21 – CONSTITUTION STREET – LAURIE STREET to BERNARD STREET [DRAFT as at 11 February 2008]

COMBINATION OF SDS AND PAUL HOGARTH PROPOSALS FOR BERNARD STREET

**EDM
COMMENTS**
14.12.07

NEWHAVEN ROAD TO HAYMARKET
BERNARD STREET TRAMSTOP
PROPOSED GENERAL ARRANGEMENT
DETAILED DESIGN

EXISTING CONDITION

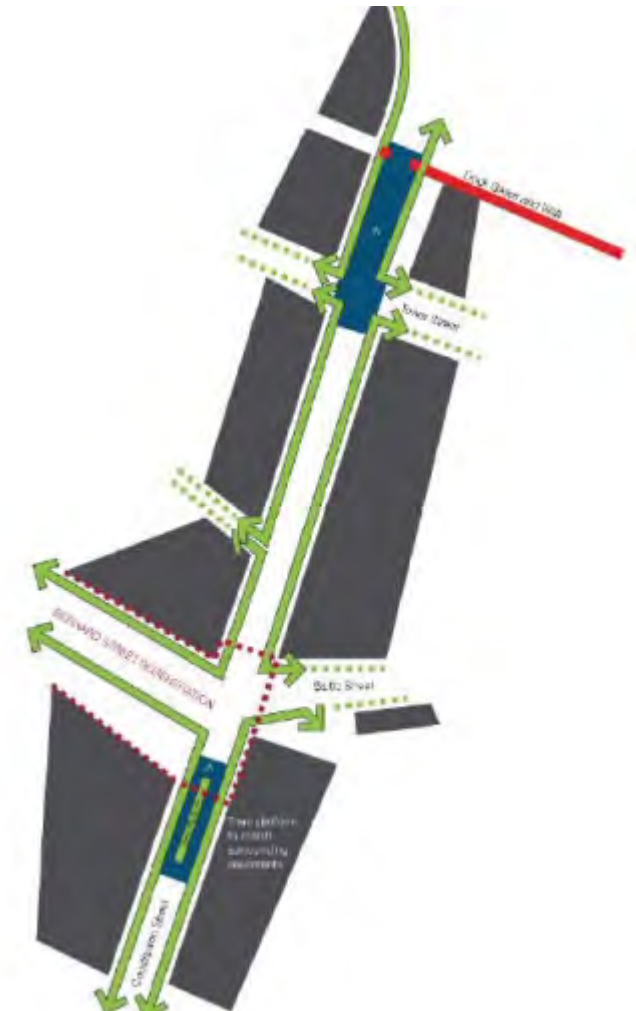
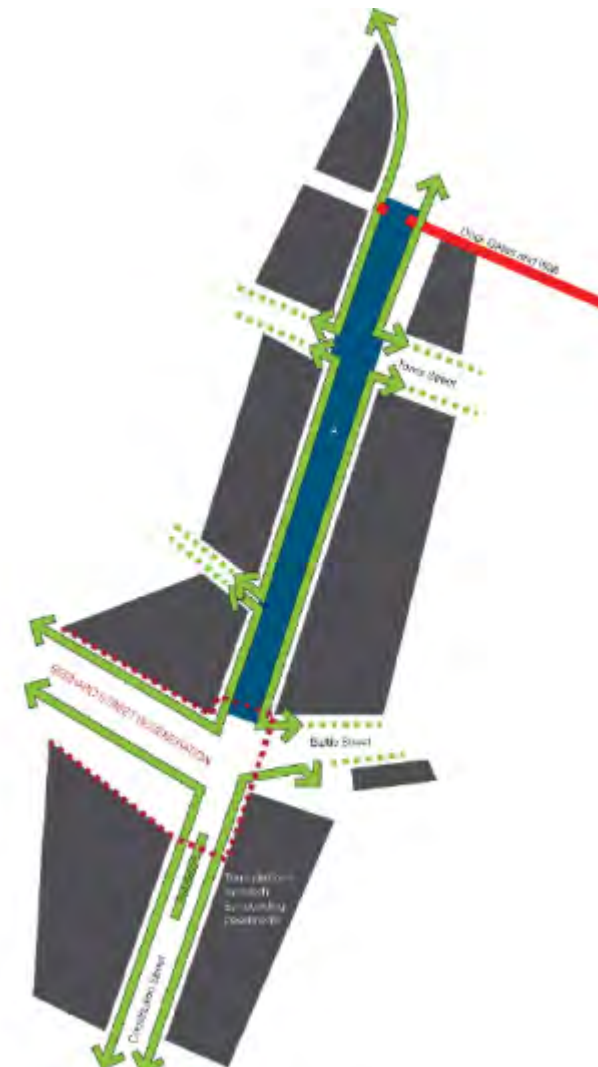
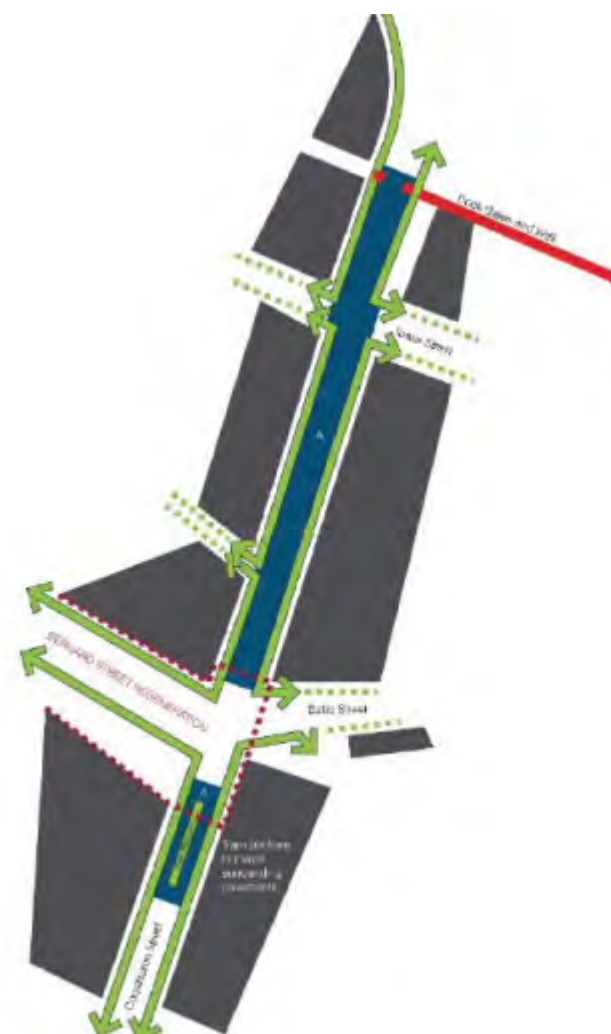
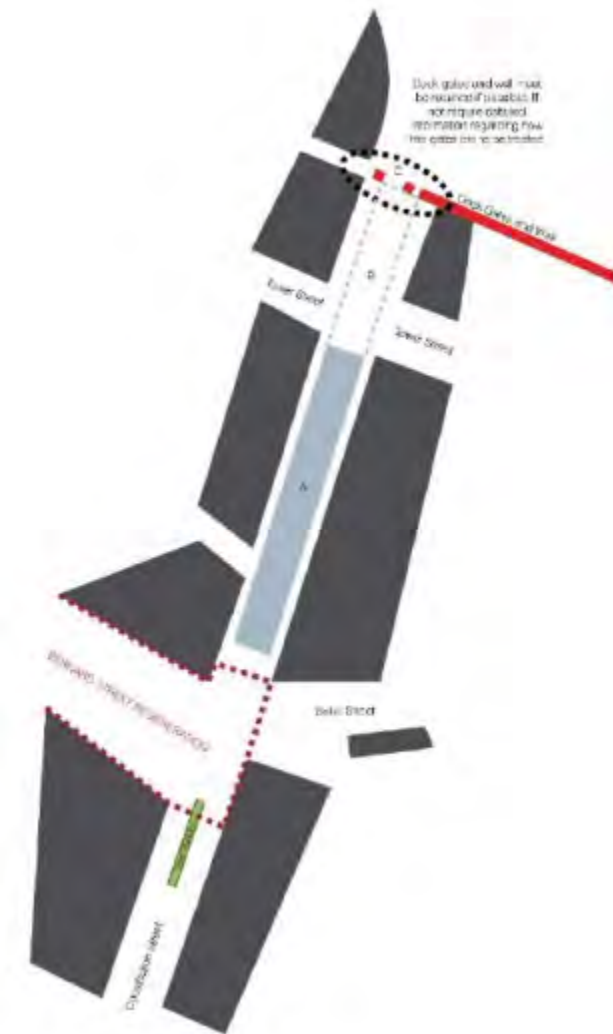
Street (including exposed setts and setts covered with asphalt) will need to be dug up and reinstalled with new sub base to meet tram requirements.

Current extents of exposed setts not in best location in design terms.

Area of setts covered under asphalt is unknown.

In principle, surfaces should be replaced 'like for like'. However there is an opportunity to rationalise the design at this point.

These gates must be retained.

Can tram go through these?

If not require detailed information regarding how the gates are to be treated

- A. Current extents of exposed setts. Would not make design sense to replace like for like in this location.
- B. Likely to be larger area of setts covered under asphalt.
- C. Dock gates must be retained.

FOOT OF THE WALK TO THE DOCKS : SPATIAL STRATEGY

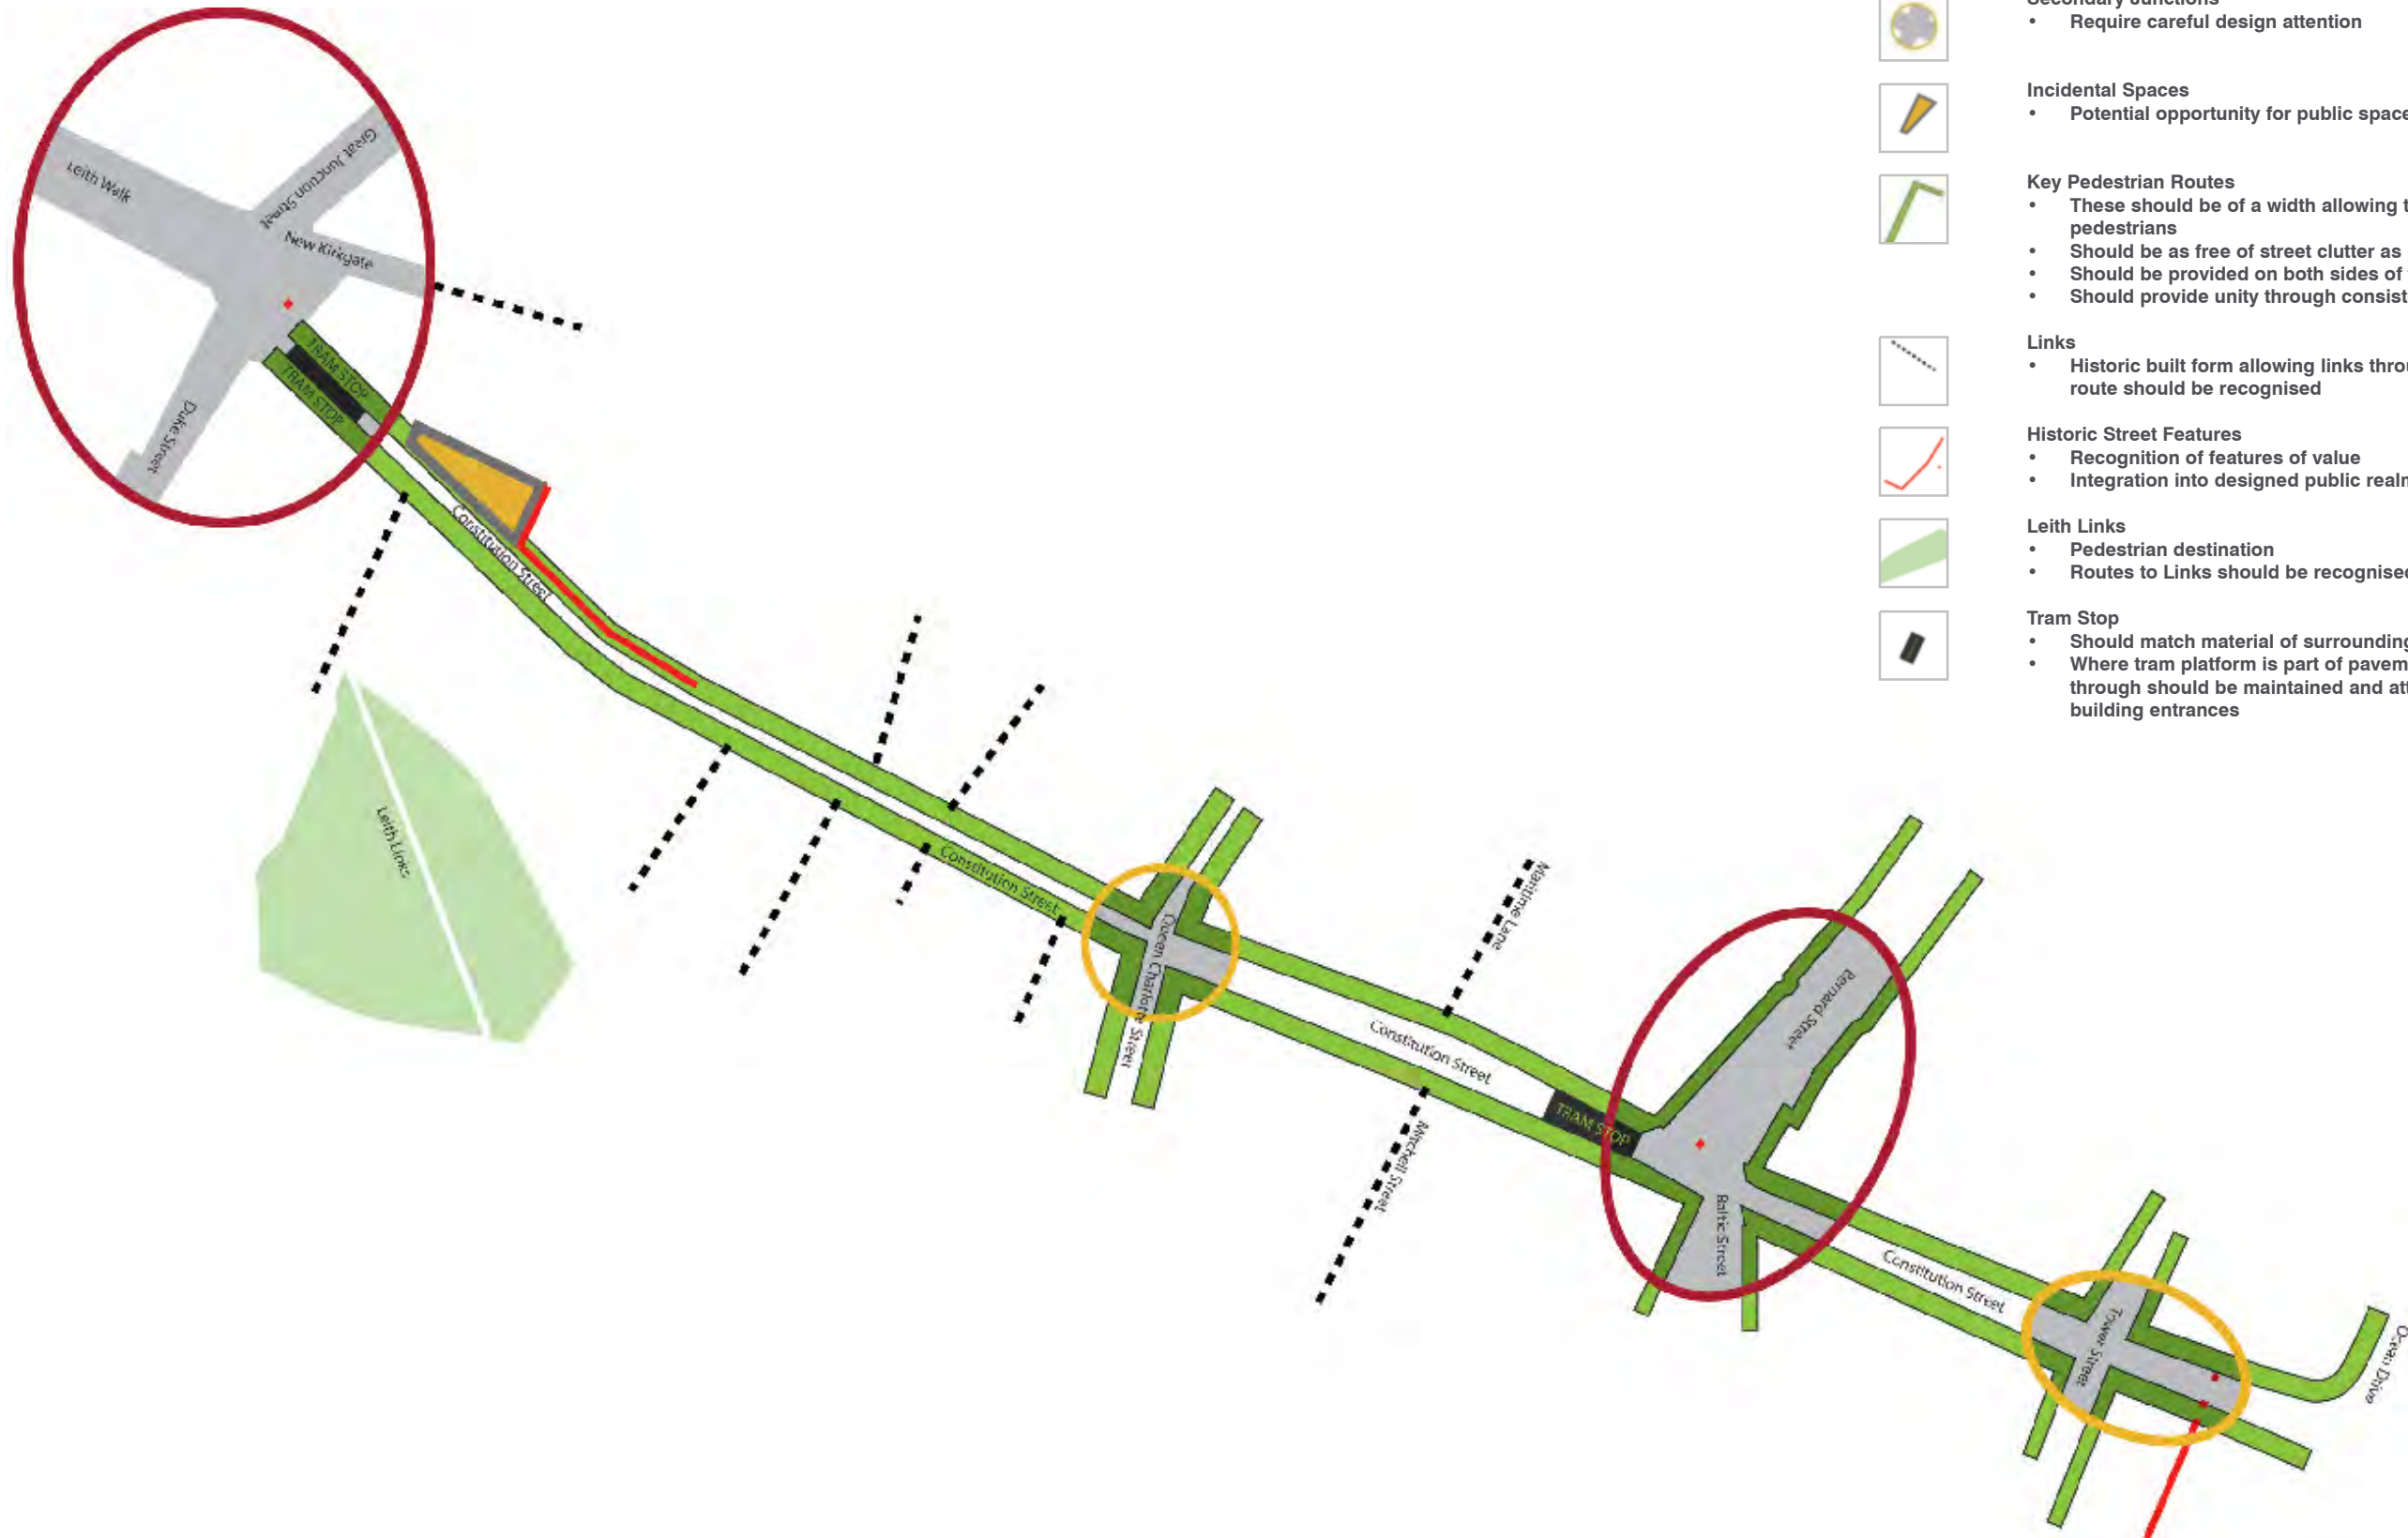
- Key Nodal Spaces**
- Requiring design and implementation
 - Creation of significant place making
 - Careful co-ordination with Tram Stop

- Key Pedestrian Routes**
- These should be of a width allowing the free flow of pedestrians
 - Should be as free of street clutter as possible
 - Should be provided on both sides of the street
 - Should provide unity through consistent material use

- Tram Stop**
- Should match material of surrounding pavement
 - Where tram platform is part of pavement clear route through should be maintained and attention paid to building entrances
